South Texas Project Electric Generating Station P.O. Box 289 Wadsworth, Texas 77483

August 8, 2000
NOC-AE-00000897
STI: 31152123
FILE NO: Z18
ER 20000127
10CFR50.4(b)(5)
10CFR50 App E

STP NUCLEAR OPERATING COMPANY
Units 1 and 2
Docket Nos. STN 50-498; STN 50-499
Changes to Emergency Plan Implementing Procedure

In accordance with 10CFR50.4(b)(5) and 10CFR50, Appendix E, Section V, the STP Nuclear Operating Company hereby submits the attached revision of three (3) Emergency Plan Implementing Procedures.

0ERP01-ZV-RE01	Rev. 1	Page 7 of 7
Recovery Operations			
Addendum 1	Recovery Organization		Page 1 of 1

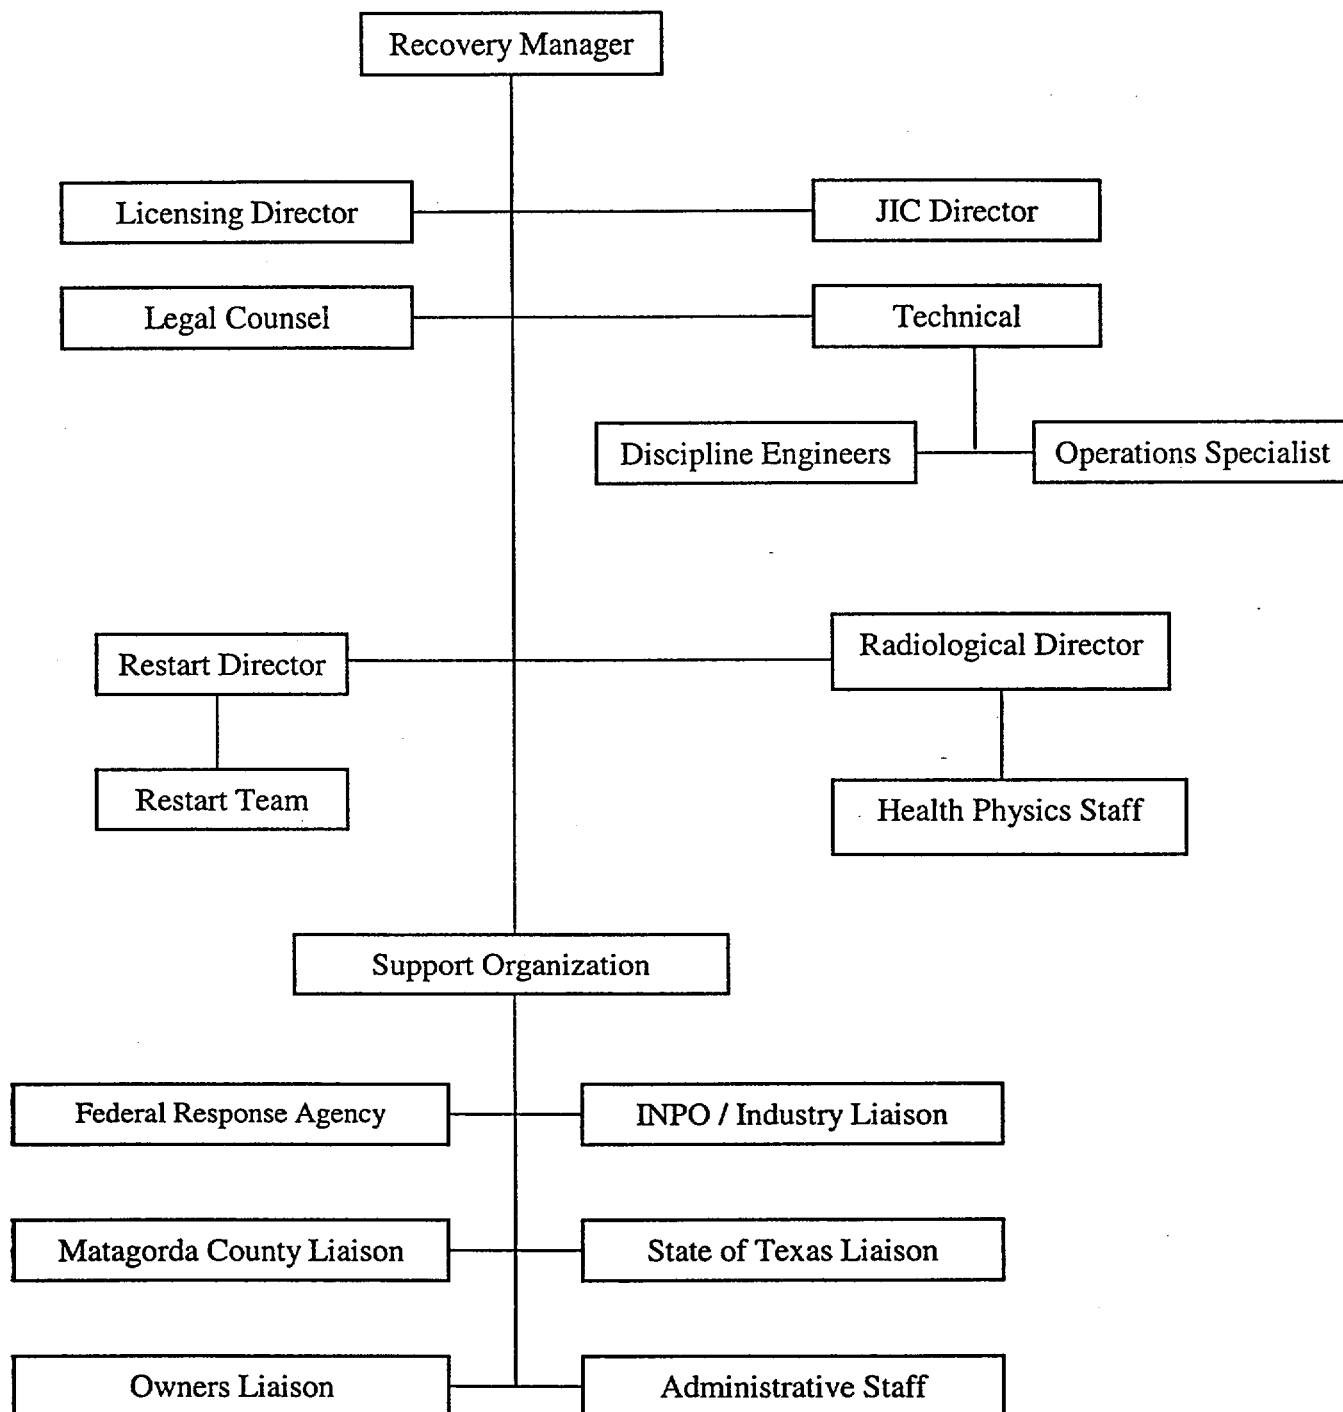
Change No.	Change to Revision 0	Reason
5.	Added new 5.6 – termination from recovery phase	Not specified in current revision
6.	Added new Addendum 1.	Request of reviewers.

Sample Area Map

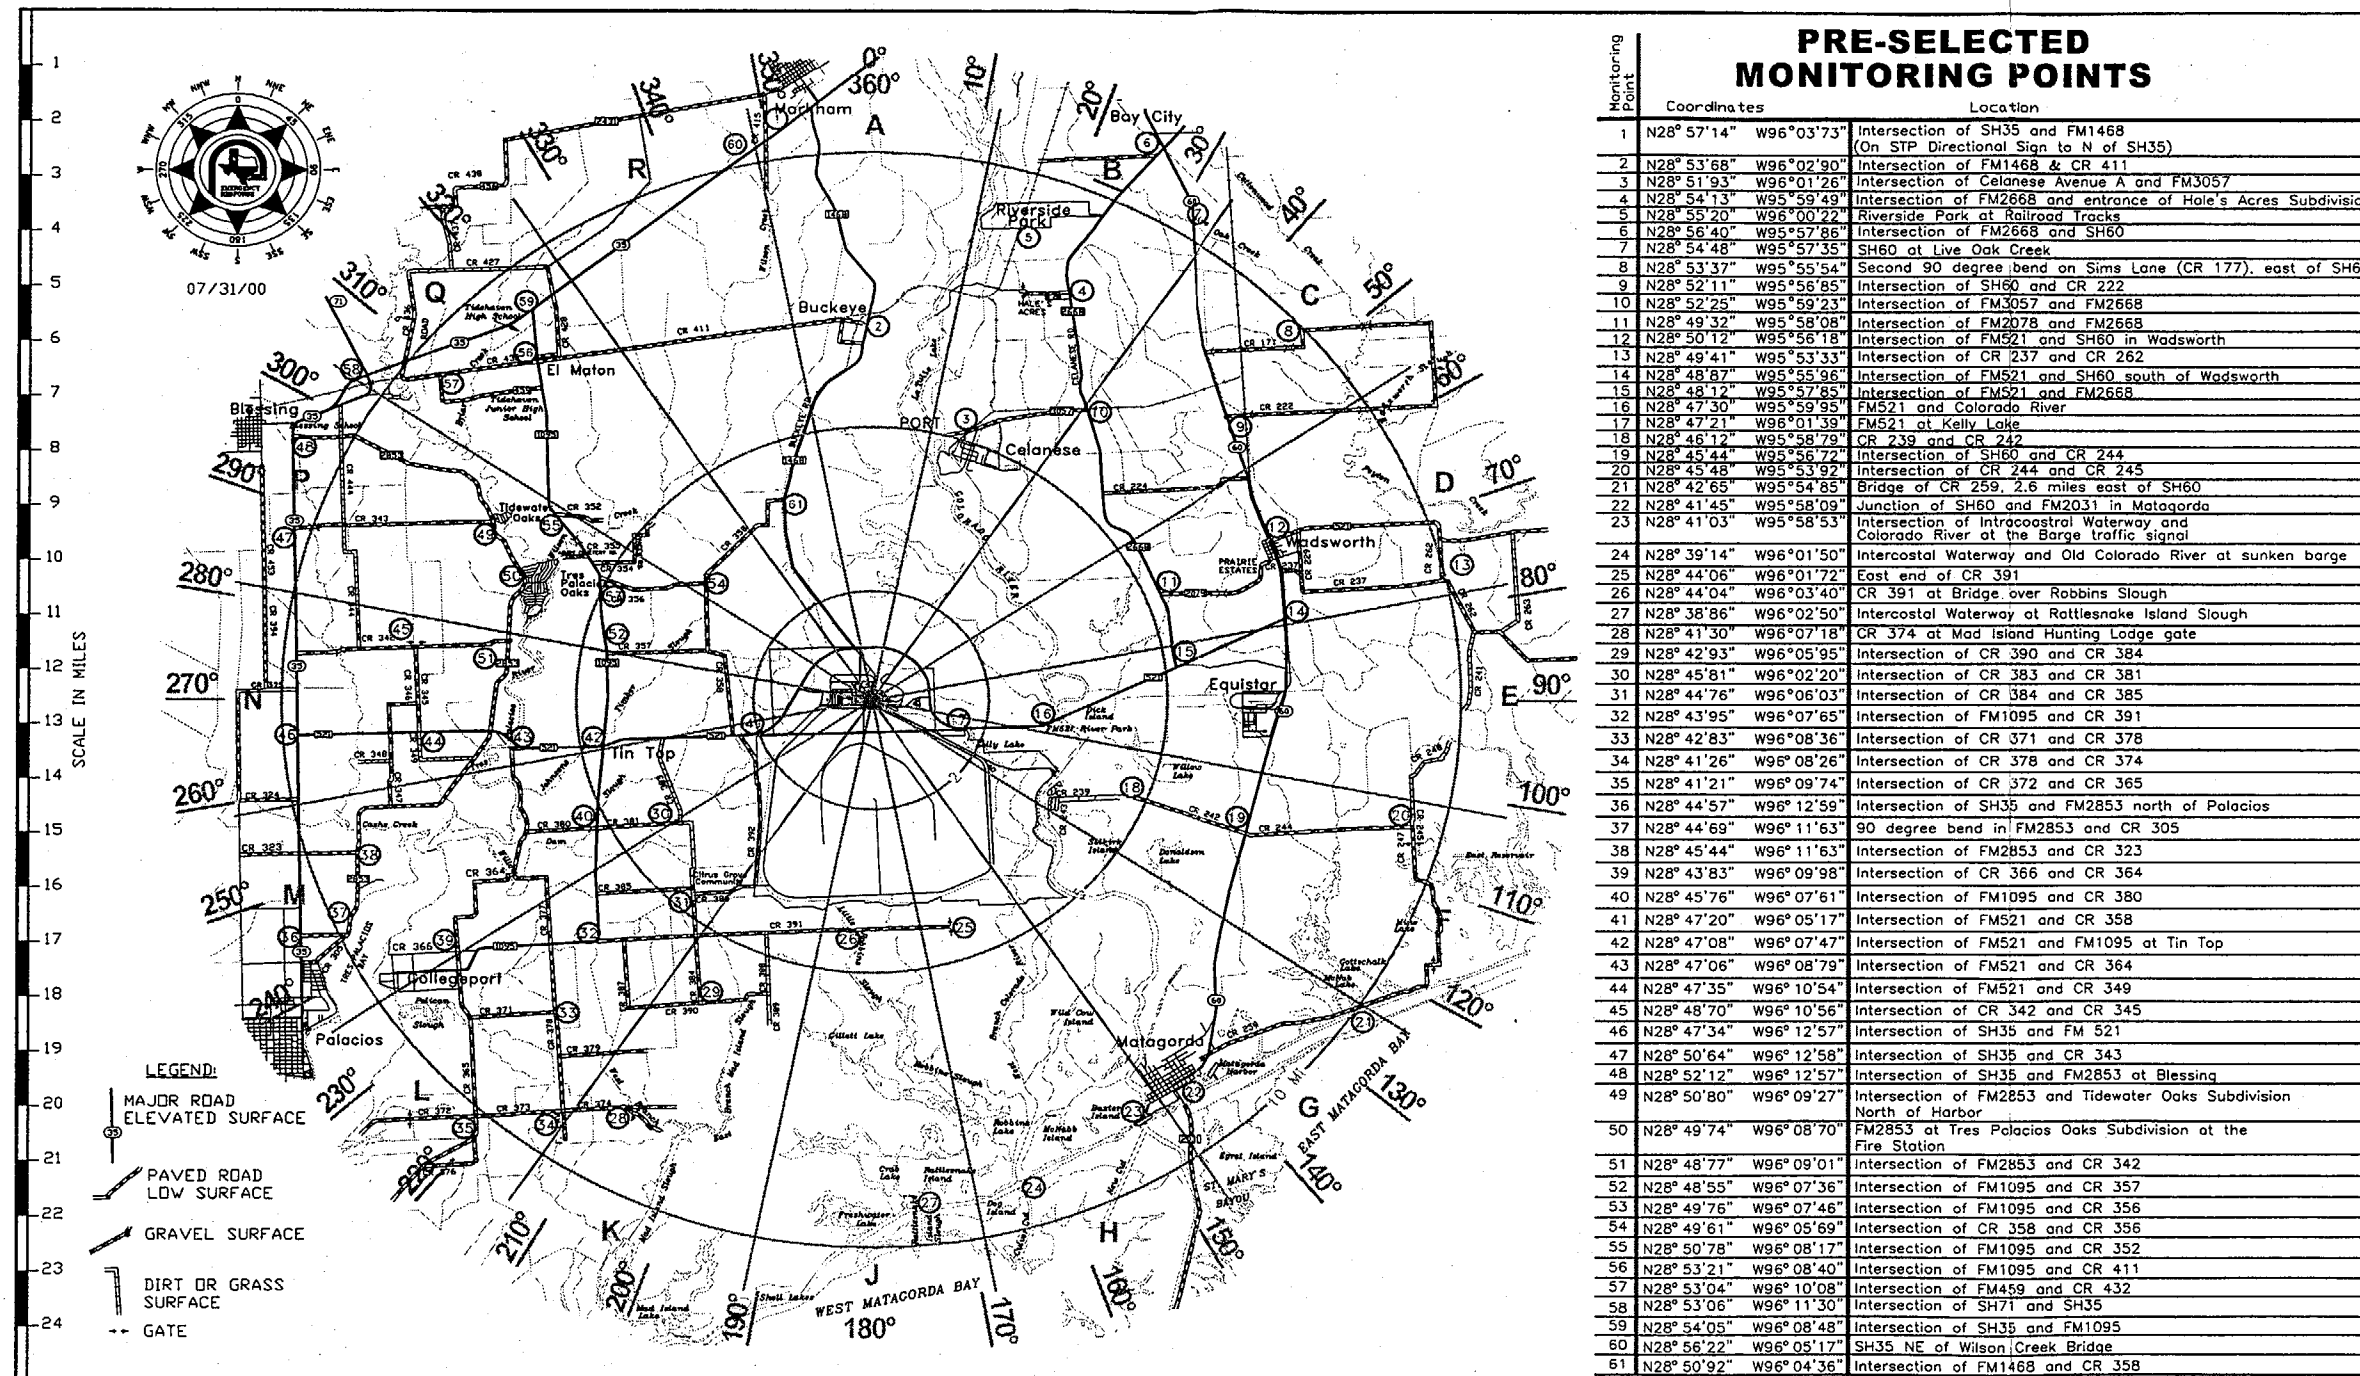
- Changed Procedure usage to N/A to comply with procedure 0PGP05-ZV-0004, Emergency Plan Implementing Procedure Users Guide.
- Removed 36 BRC/State respirators w/filters.
- Revised Addendum 6 Sample Area Map, added GPS data.
- Revised Form 2, Sample Analysis Calculation Form, the formulas were not clear.
